AGENDA

Planning Commission Regular Meeting

Tuesday, November 28, 2023

AGENDA ITEM:	Request by US Home, LLC, for Approval of the Talamore 4th Addition Final Plat	AGENDA SECTION:	CONSENT AGENDA
PREPARED BY:	Julia Hogan, Planner	AGENDA NO.	4.b.
ATTACHMENTS:	Site Location, Final Plat, Grading Plan, Utility Plan, Landscape Plan, Engineer's Memo Dated November 20, 2023, Stormwater Review Memo Dated November 16, 2023, Parks and Recreation Director's Memo Dated November 17, 2023	APPROVED BY:	AK
RECOMMENDED ACTION: Motion to recommend the City Council approve the Final Plat for Talamore 4th Addition, subject to the following conditions: a. Execution of a Subdivision Agreement. b. Adherence with conditions of the Preliminary Plat and Master Development Plan approvals. c. Compliance with the conditions and standards within the City Engineer's Memorandum dated November 20, 2023 and associated Stormwater Review Memorandum dated November 16, 2023. d. Drainage and utility easements with storm sewer infrastructure, except ponding or infiltration areas, may contain fences, but shall be required to include gates to provide truck access; shall prohibit sheds or other accessory structures; and shal

STREET 08 - ARBORVITAE CIRCLE

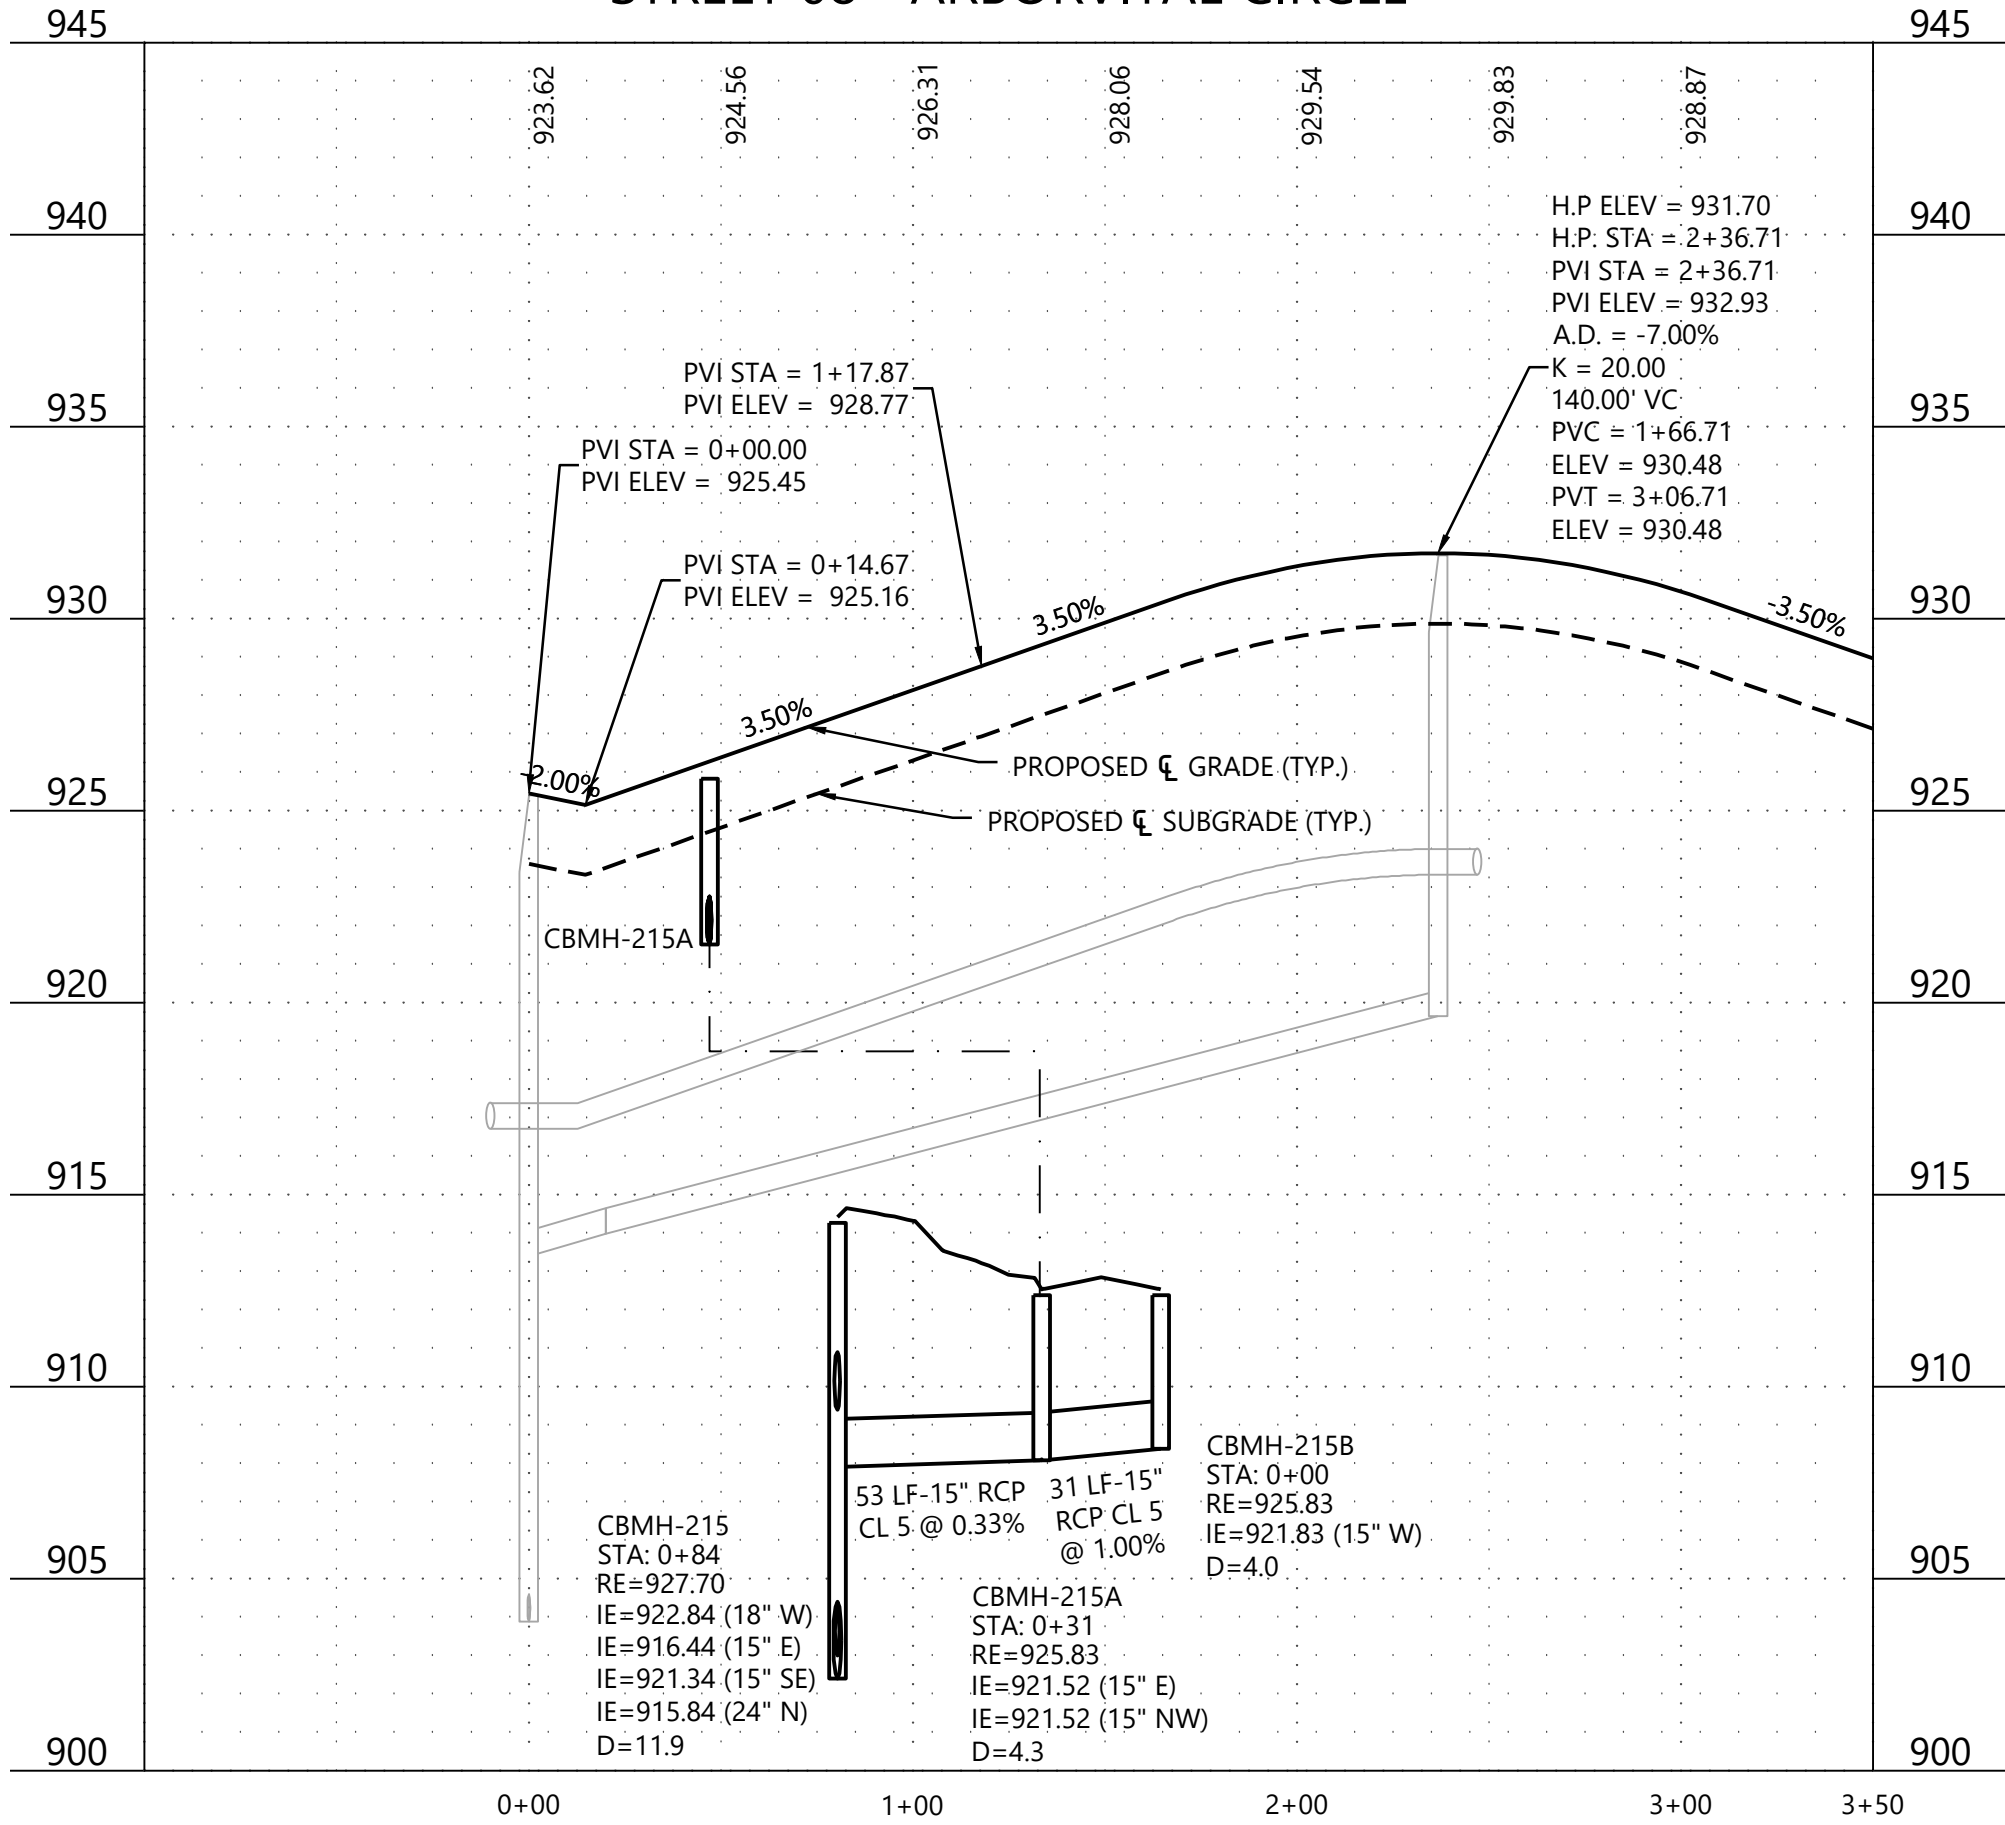
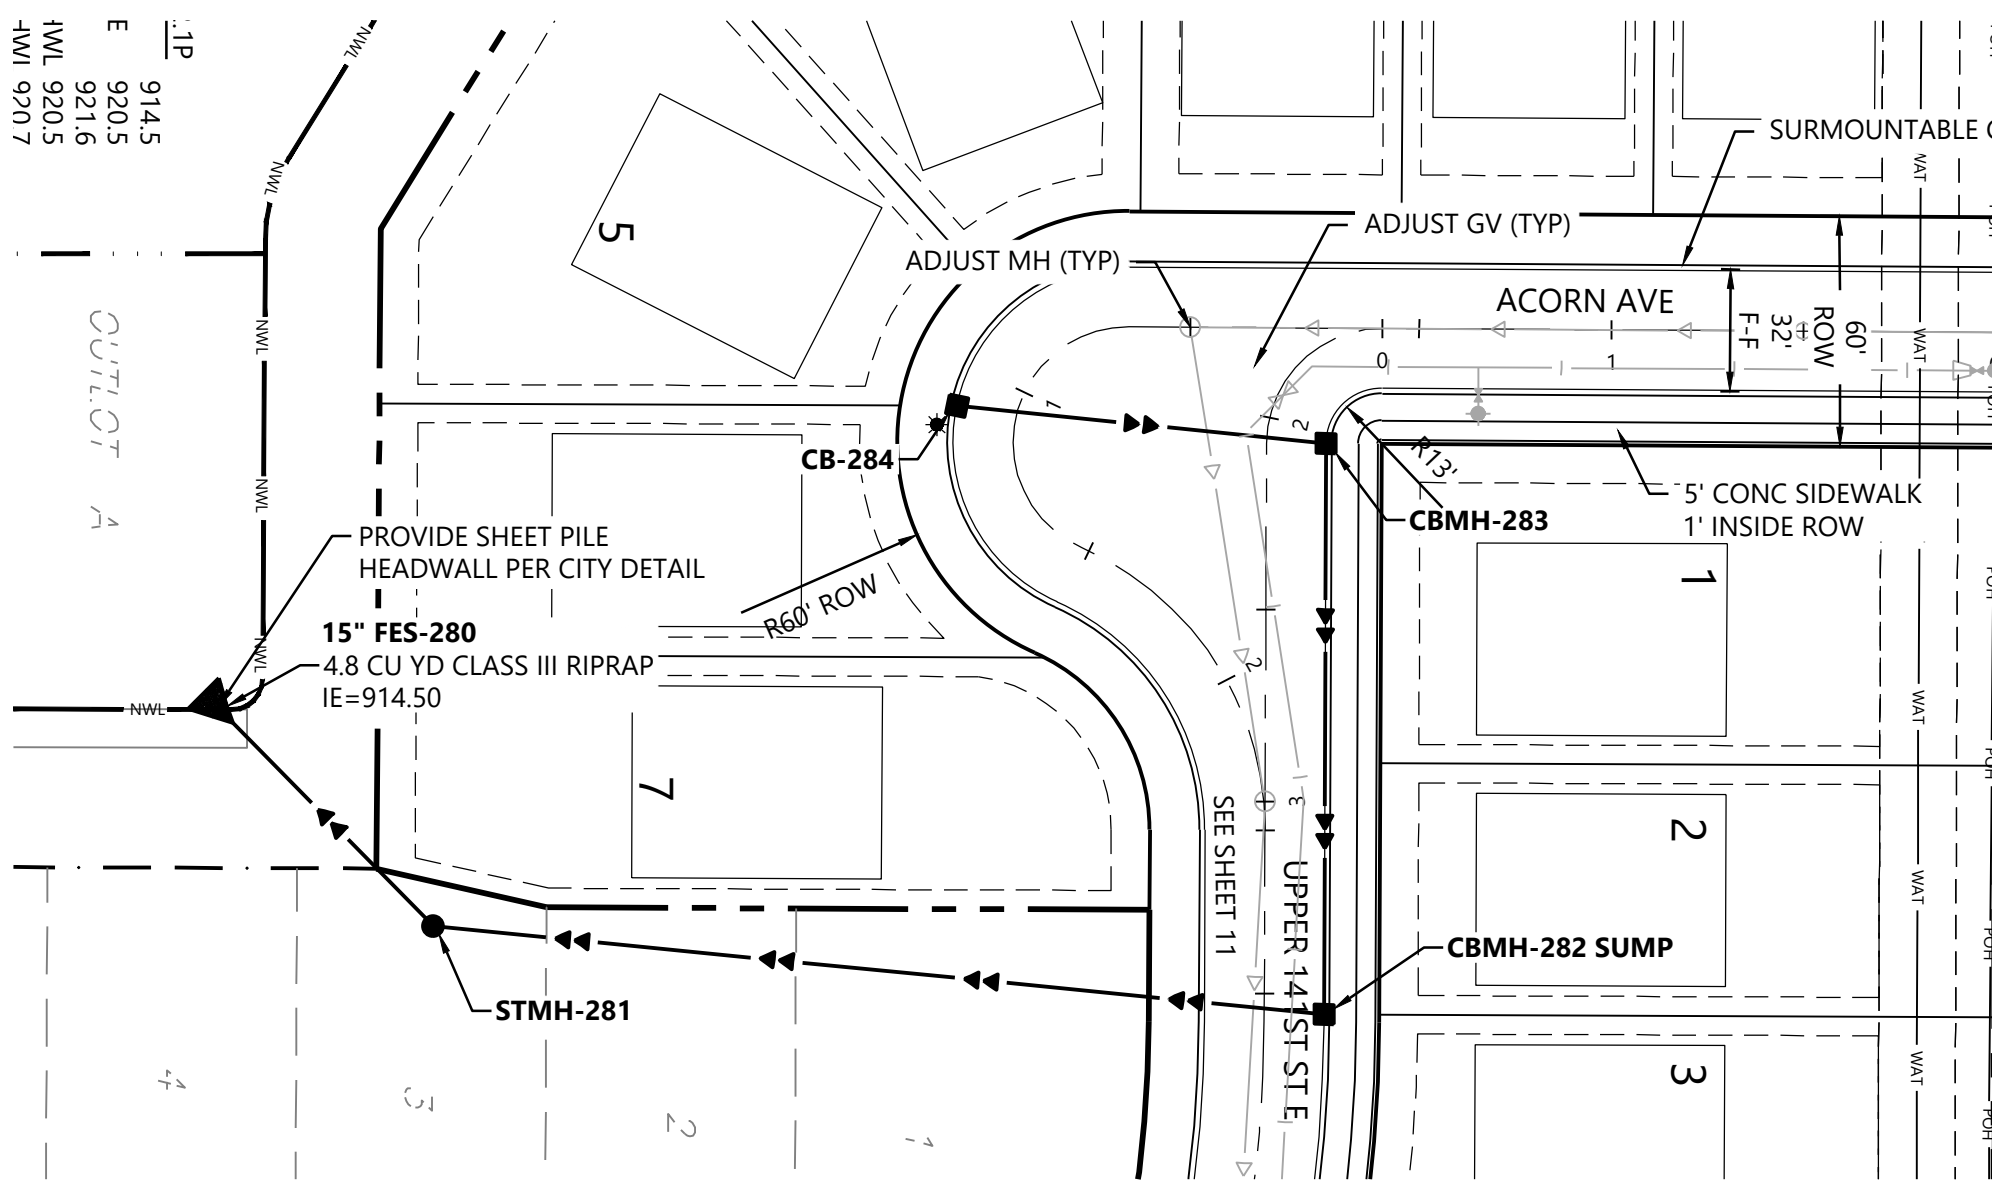
10. The easement for the sanitary sewer between MH-32 and MH-29A is ~20' from center while the sanitary sewer is 25' deep
11. Show the property lines on the Arborvitae Circle Plan View on sheet 5 of 19.

DWG. NO:
C400.00
SHEET SIZE: E (36"x48")

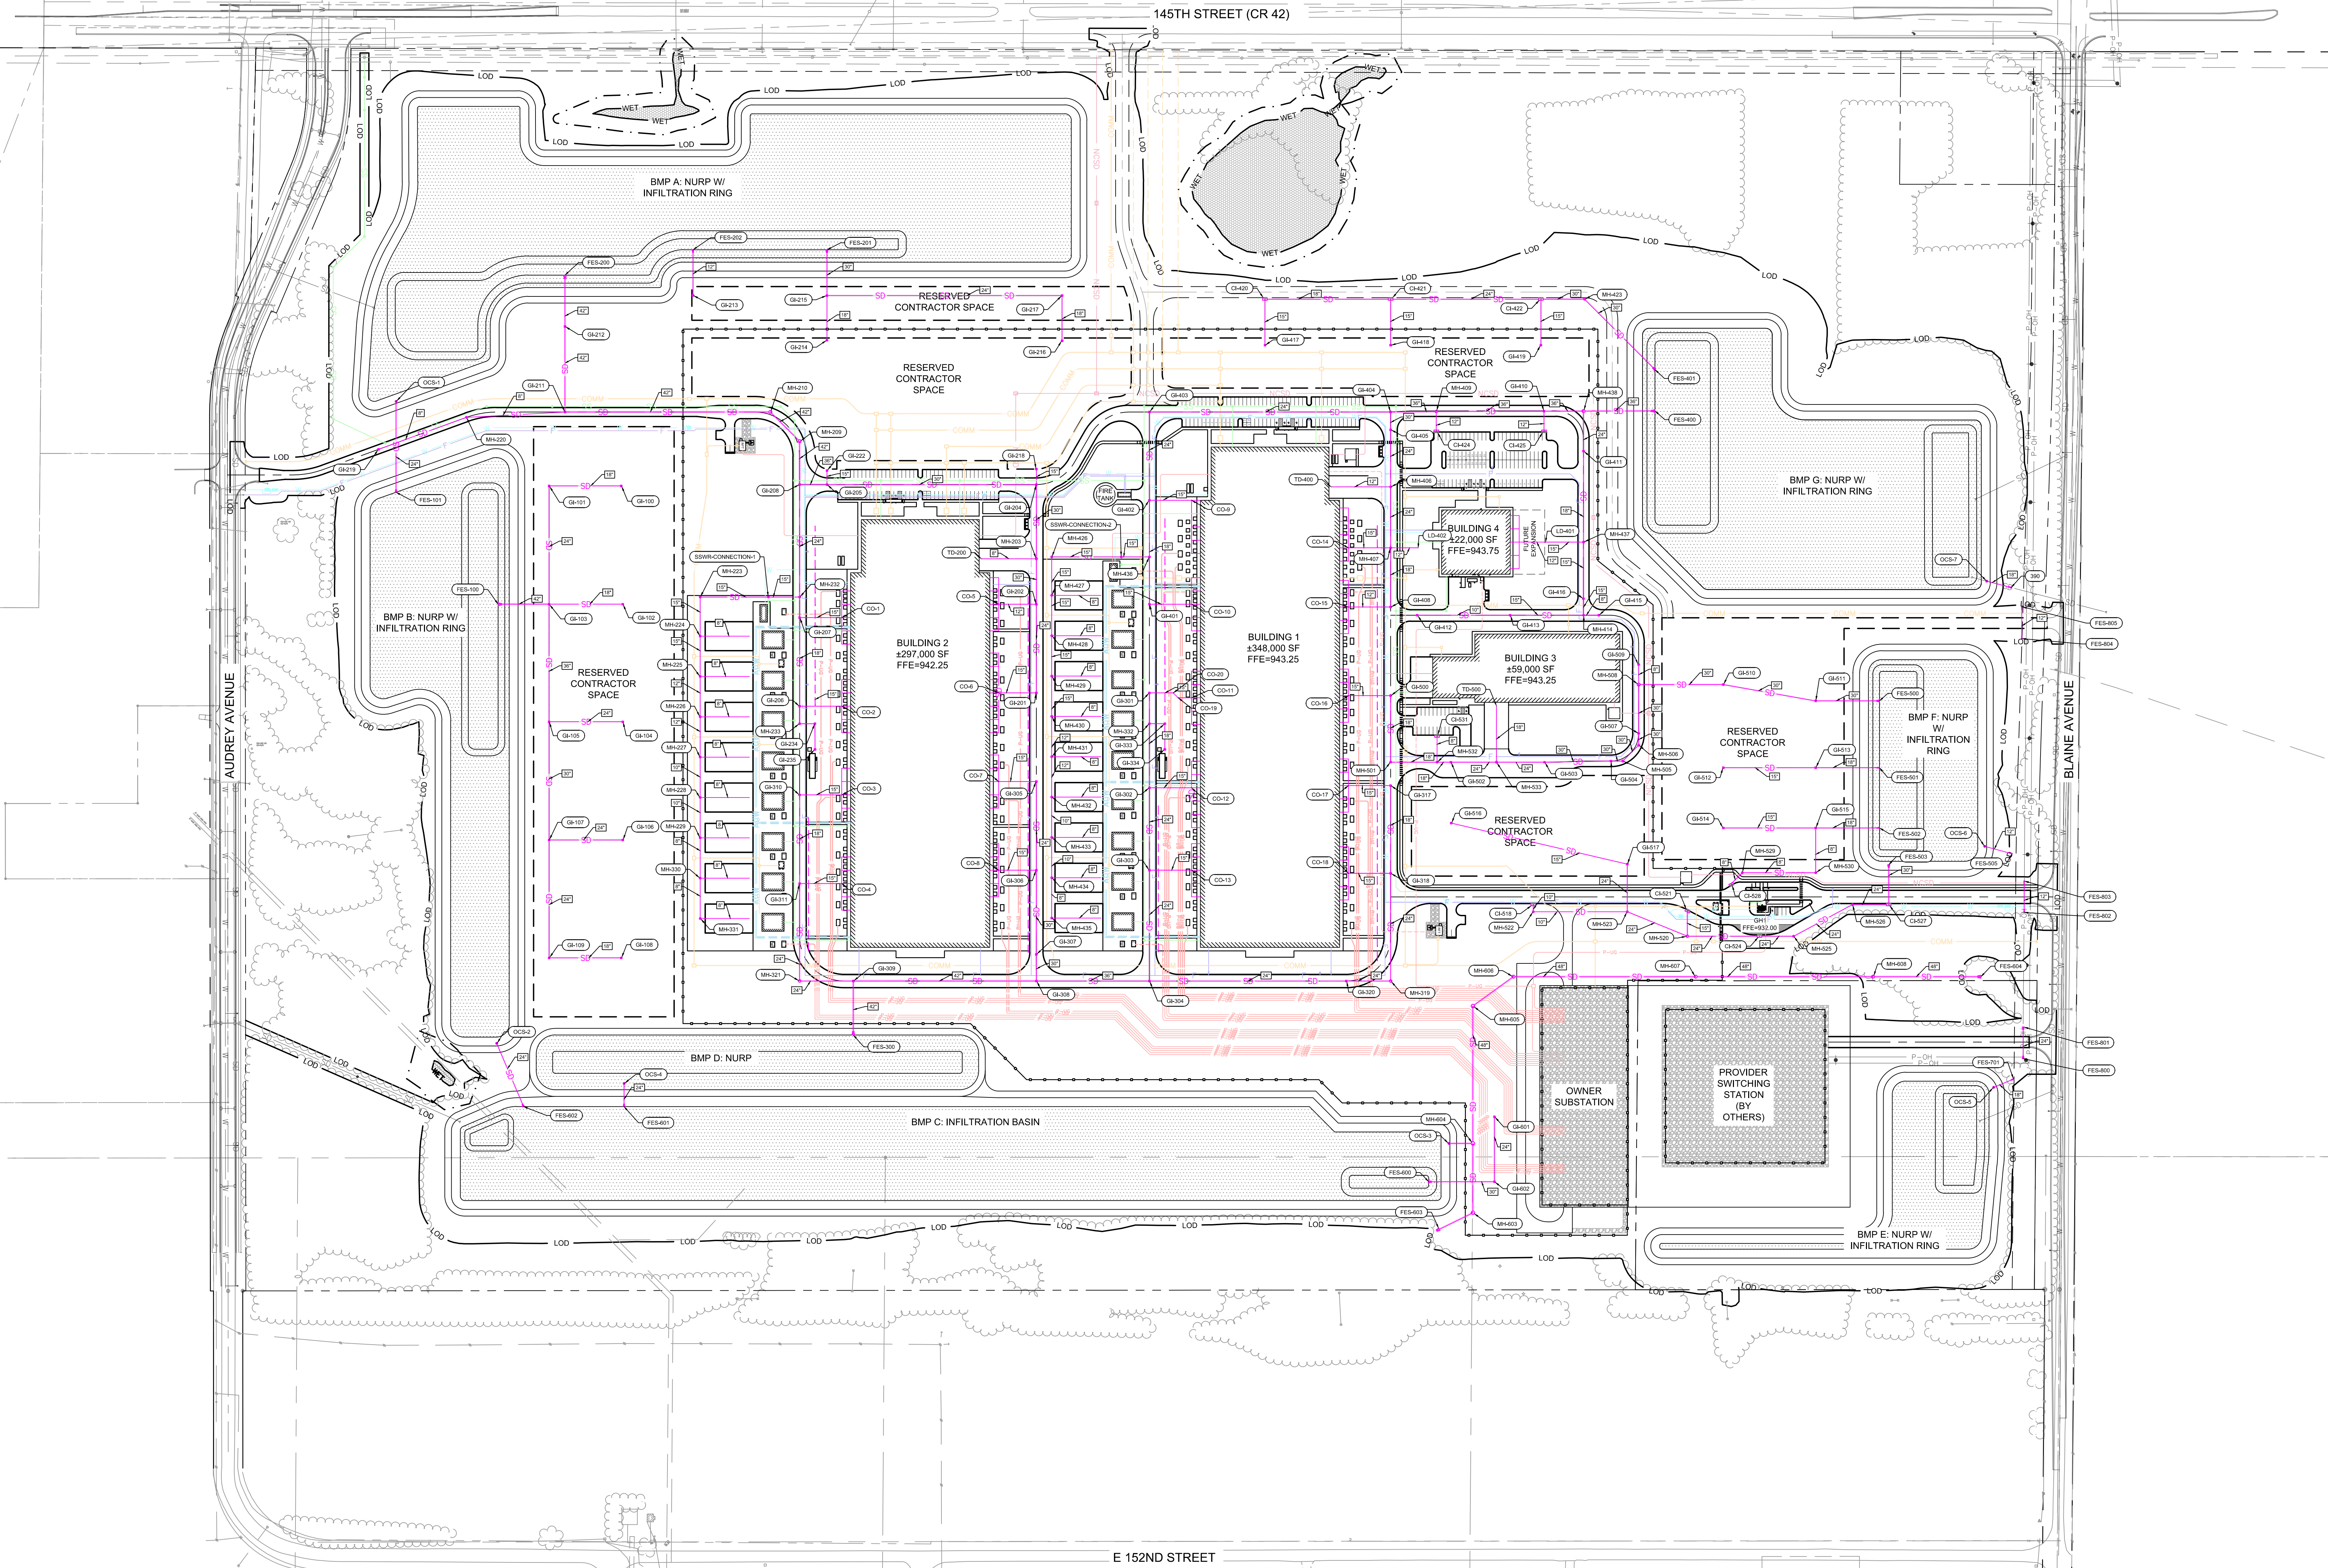
- a. A NPDES permit will be required since over an acre of disturbance is proposed.
- b. Signed plans will be required for final permit approval.
- c. An operations and maintenance agreement is required to specify parties responsible for specific stormwater maintenance obligations.
 - i. It is recommended to divide BMPs based on if they receive runoff from private site storm sewer or public road storm sewer.
- d. The electronic version of the HydroCAD model is requested to be submitted with future submittals to aid in review.
- e. See additional redline comments on Sheet C300.00

- a. Changes to overall BMP locations and flow are recommended to ease long-term maintenance responsibilities and integrate the basins into the City's surface water management plan. These changes are summarized on the markups of plan sheet C300.00.
